Subject: Draft Environmental Impact Report for Valiano Development

## Rincon del Diablo MWD Comments May 2015 – Valiano Development Draft EIR

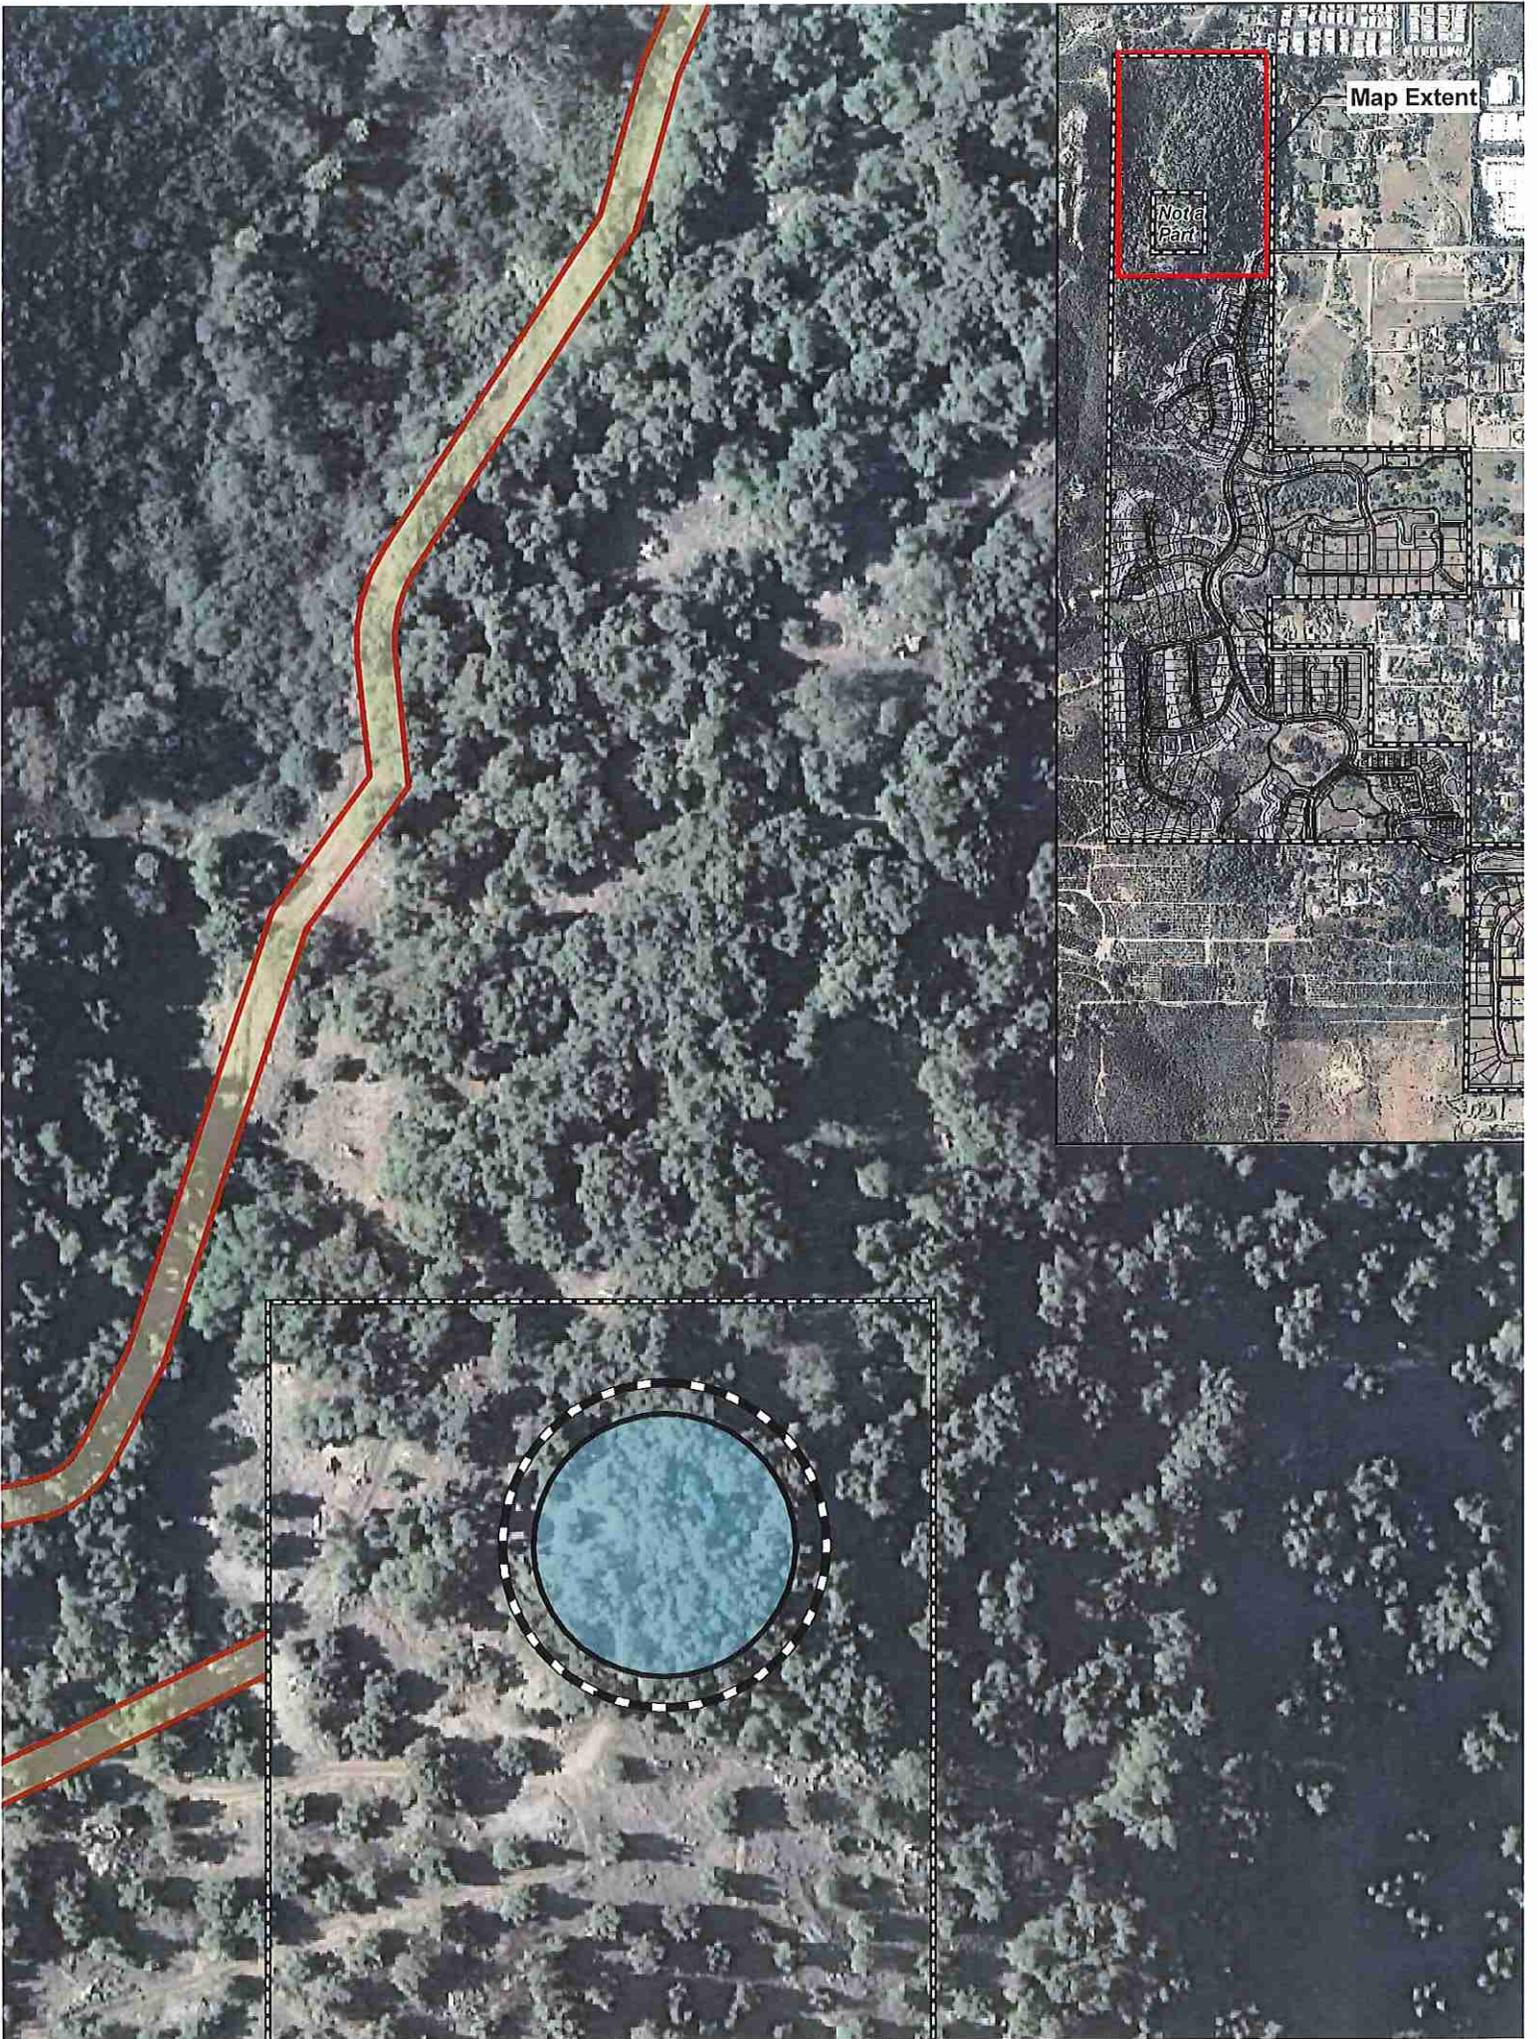
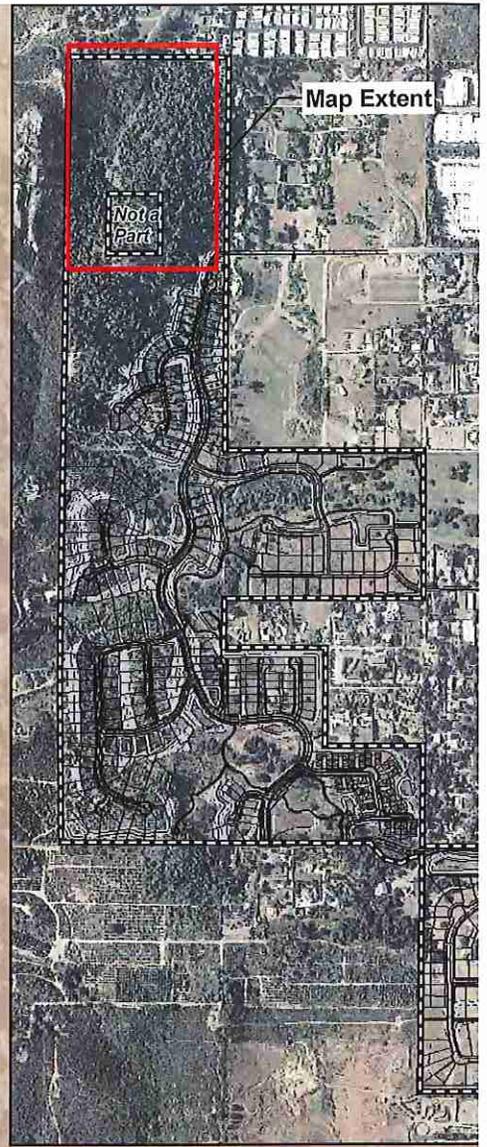
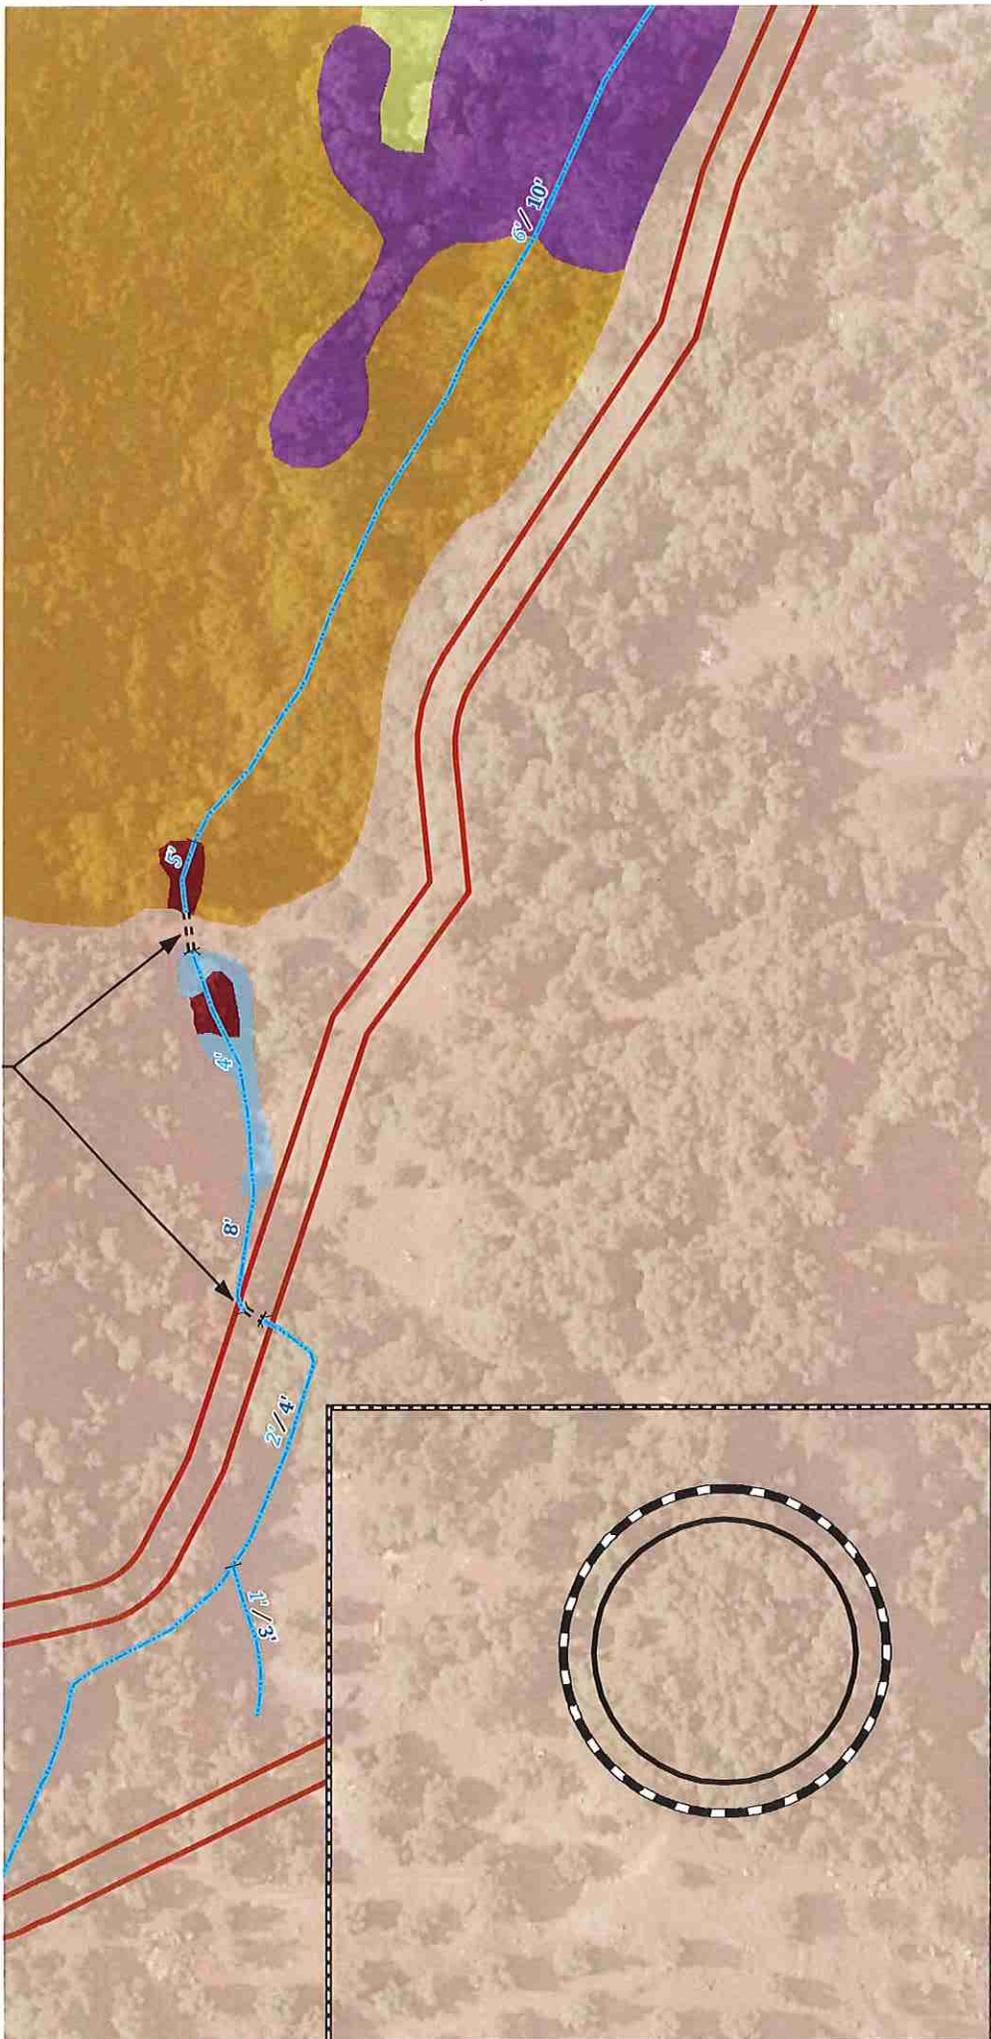
Comment 11 – Per our cover letter, the R7 Reservoir is an expansion based, developer driven project, and is a facility requirement for the project. Please reword accordingly and delete reference to a future Rincon Water project.

Comment 13 – See Comment 11, delete “(but not a part of)”, and delete mitigation by Rincon Water. Please also address in Chapter 7, Mitigation Measures.

Comment 14 – Access may also be required from the subdivision road. All access roads will be paved. Delete reference to Rincon Water building the facility at a future date.
